**AGENDA PACKET**

**JANUARY 11, 2022 MEETING**

**397 Smith Ridge Road, LLC; 397 Smith Ridge Road, South Salem; Sheet 50A, Block 9848, Lot 2 (397 Smith Ridge Road, LLC, owner of record) - Application for an addition to an existing self-storage facility.**

RE: Site Development Plan Approval, Wetland Activity Permit, and Stormwater Permit  
397 Smith Ridge Road, LLC  
397 Smith Ridge Road  
Sheet 50A, Block 9848, Lot 2

Catch Basin (CB-1)

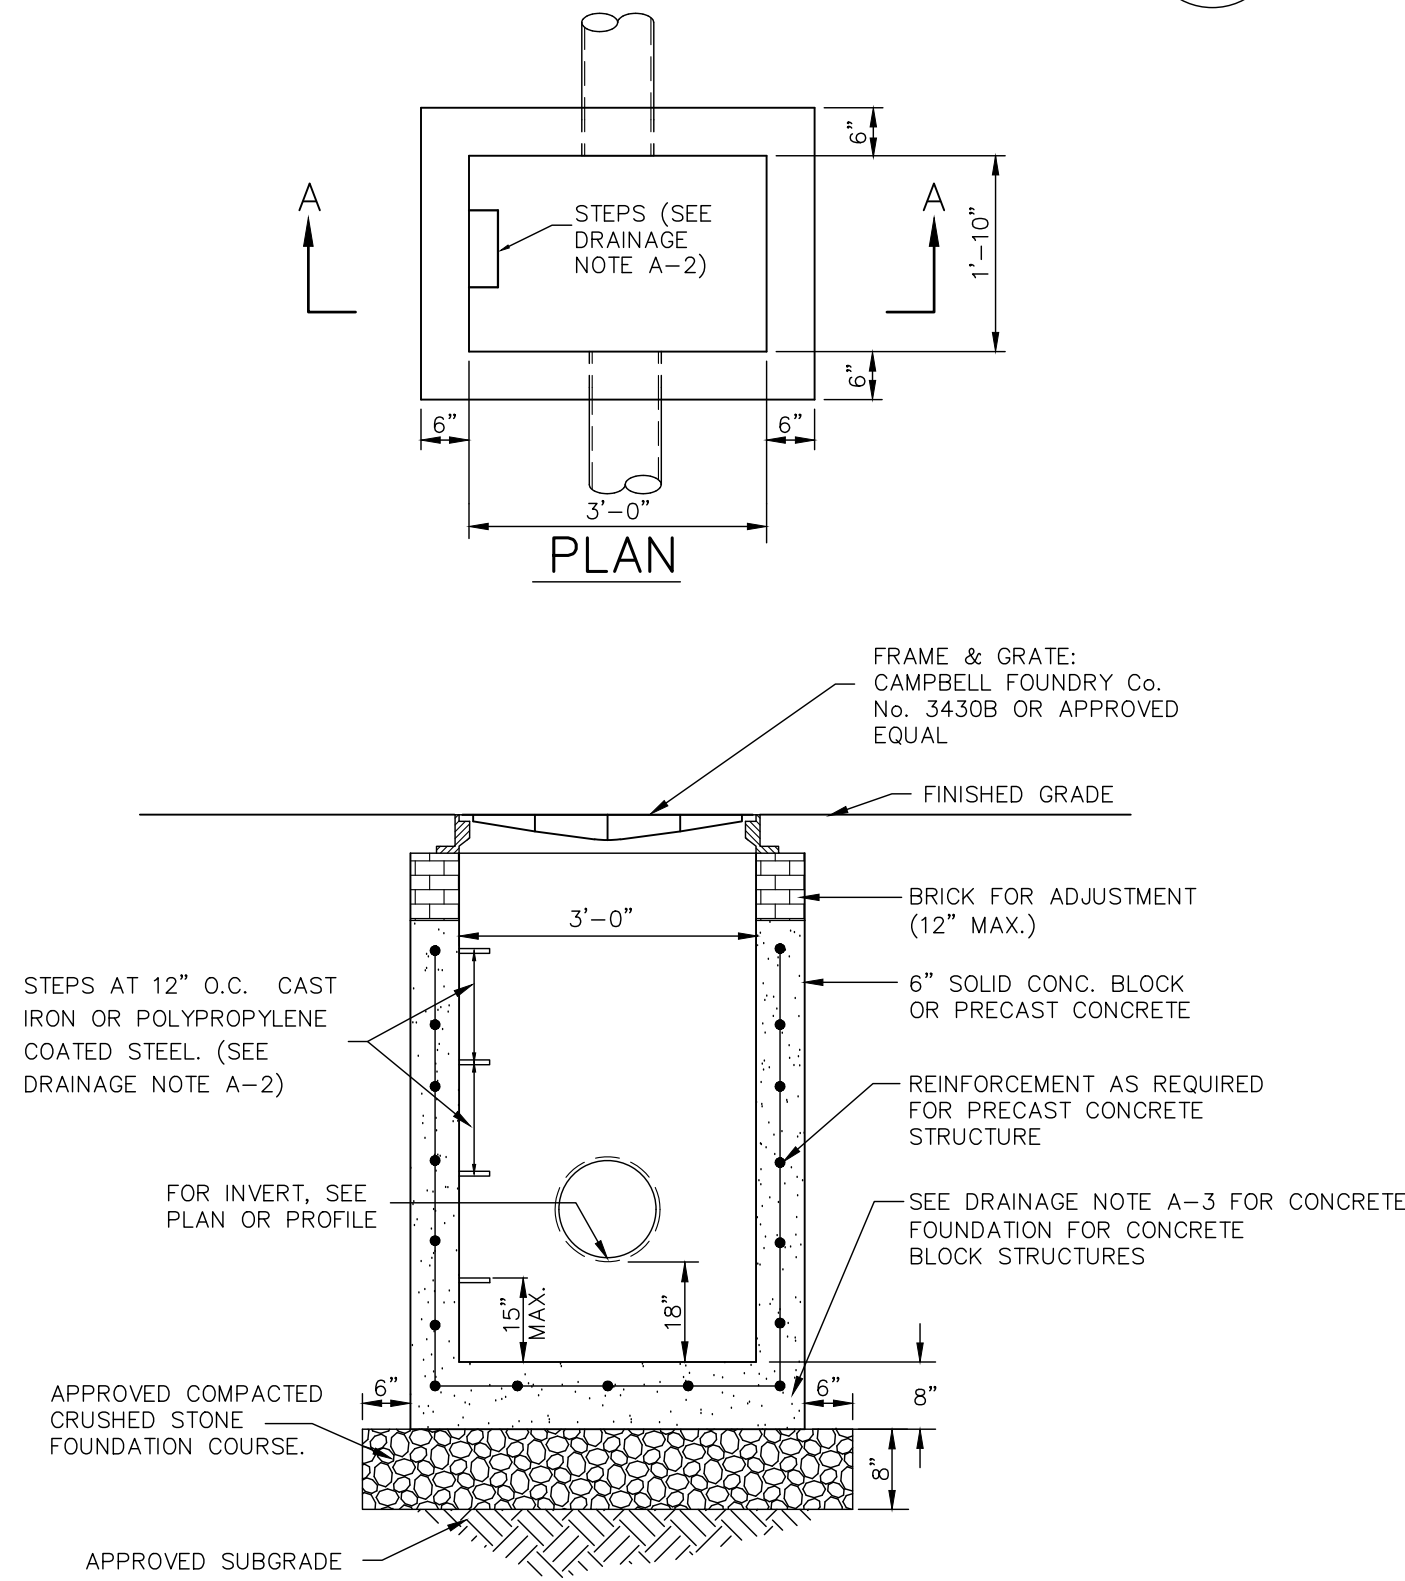
8. Please provide invert elevations for all inlet and outlet piping connections at Existing Catch Basin, CB-1. It is unclear whether pretreatment of stormwater runoff is being provided prior to discharge to the proposed 12 infiltration units. Please provide a detail for the required modifications to the existing catch basin.
